SUBJECT: Design Alternatives for Low Volume Driveway Highway Occupancy Permits

This Strike-off-Letter (SOL) replaces SOL 494-24-3 issued October 4, 2024, and corrects a truck volume typo on the alternative driveway design templates.

This SOL provides the highway occupancy permit (HOP) applicant with alternative designs for low volume driveways to accommodate combination trucks, buses, and single-unit trucks using flush corrugated concrete aprons for certain scenarios. In addition to the existing Low Volume Driveway design standards found in Chapter 2.8, page 48 of Publication 282: Highway Occupancy Permit Operations Manual, the Alternative Low Volume Driveway design standards will include:

**Alternate Low Volume Driveway with Consideration for
Combination Trucks, Buses, and Single-Unit Trucks**

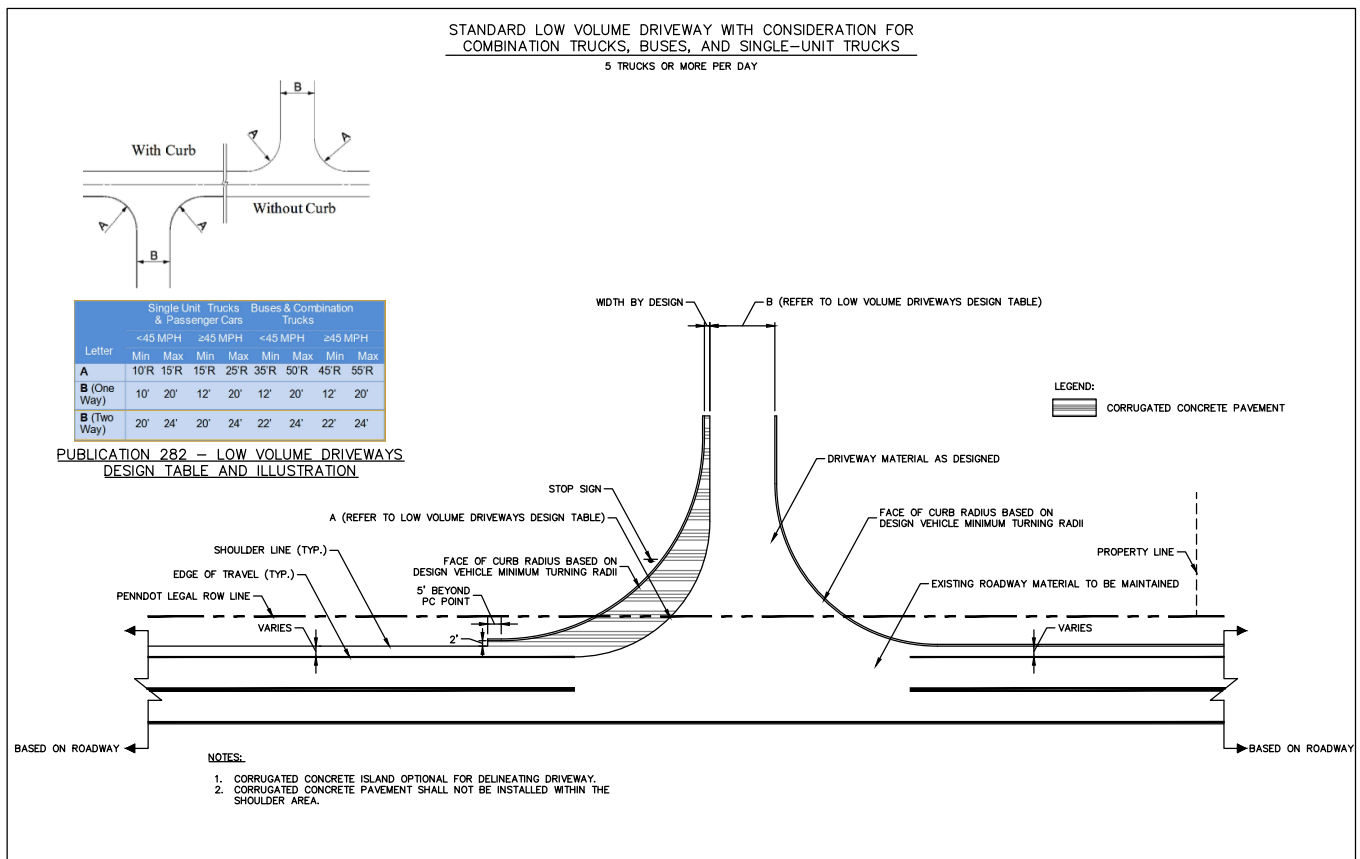
Refer to the alternate low volume driveway designs below when larger occasional vehicles do not meet the standard low volume driveway design parameters. An example of this would be a land use that traditionally services passenger vehicle traffic but also receives daily deliveries from combination vehicle(s). It is the responsibility of the applicant to understand the land use's day-to-day impacts.

Flush corrugated concrete pavement can be used for delineating driveways used by both passenger cars and heavy vehicles, to help prevent encroachment onto opposing lanes. The flush corrugated concrete pavement design is shown on page 48B. If the flush corrugated concrete pavement overlaps a pedestrian crossing an appropriate cut-through must be provided for ADA compliance. Flush corrugated concrete pavement shall not be installed within the shoulder area.

Alternate Low Volume Driveway with Consideration for Combination Trucks, Buses, and Single-Unit Trucks

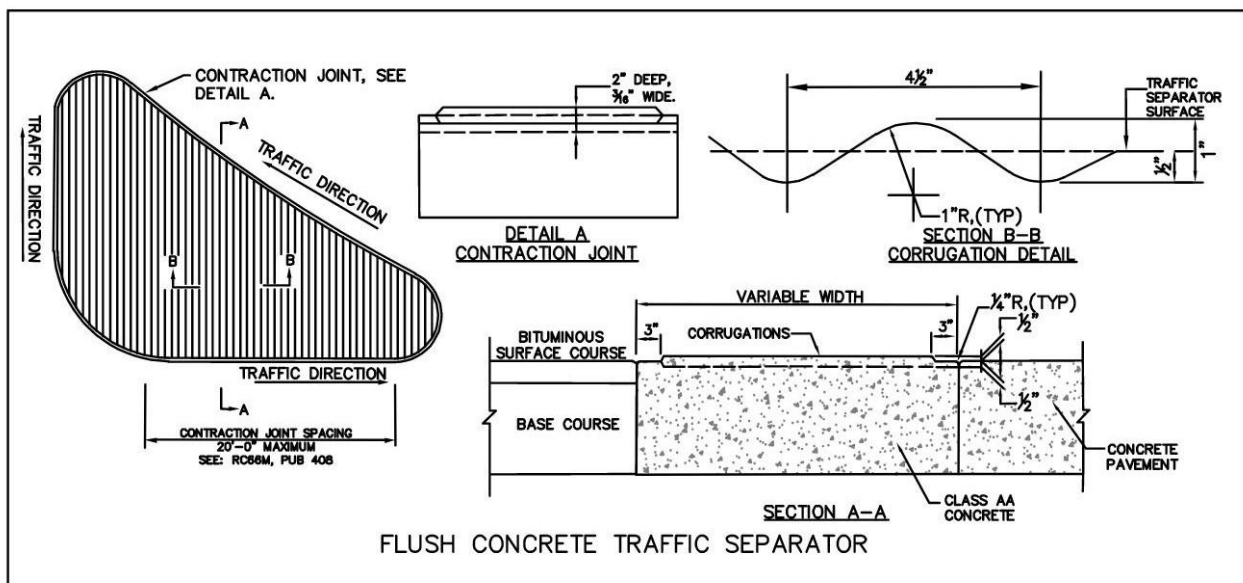
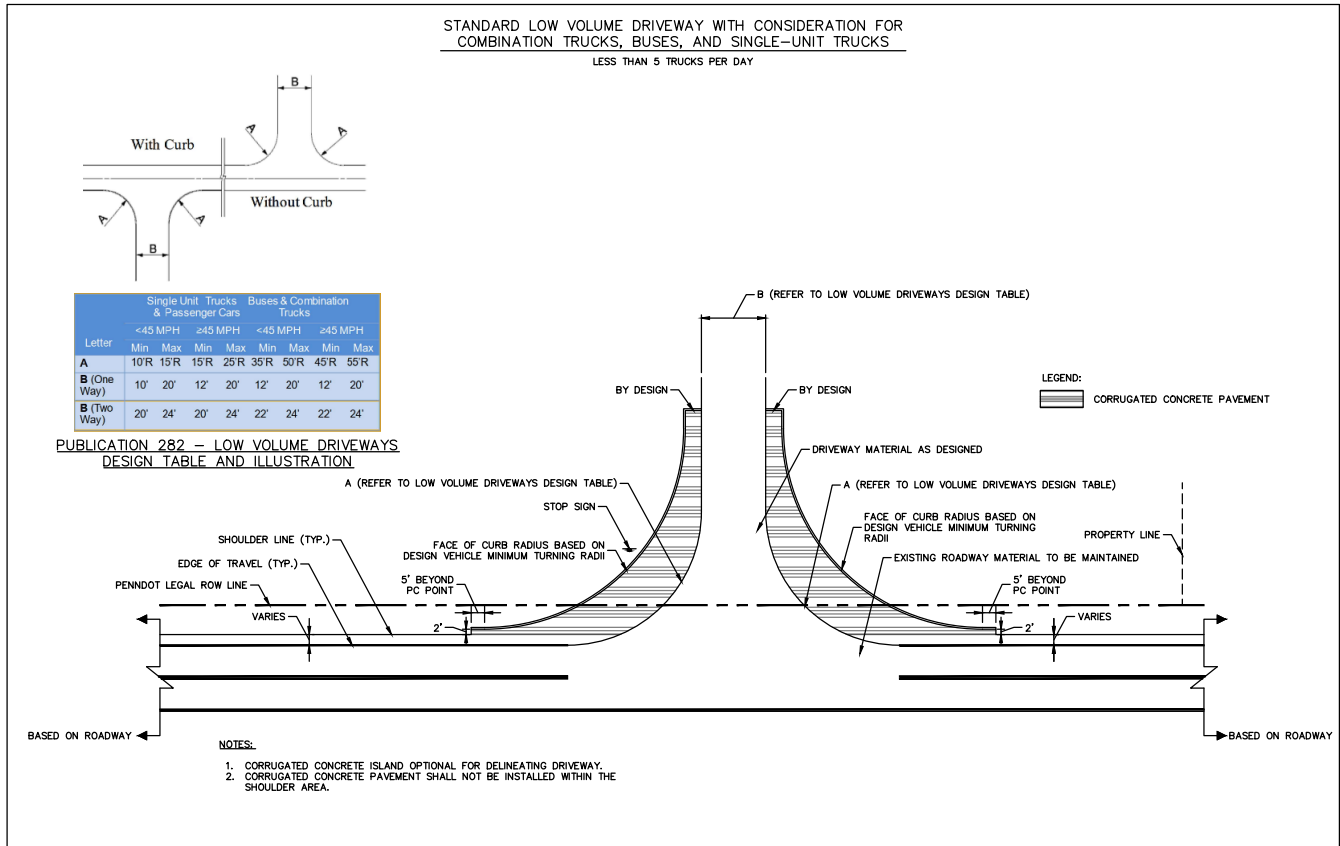
The design preference is flush corrugated concrete pavement; however, roundabout truck apron curb may be considered in certain situations, per Publication 72M, RC-65M. When roundabout truck apron curb is used, it should be dyed, stained, or painted to avoid being mistaken for sidewalk. If a pedestrian crossing is required, flush corrugated concrete pavement shall be used in place of roundabout truck apron curb.
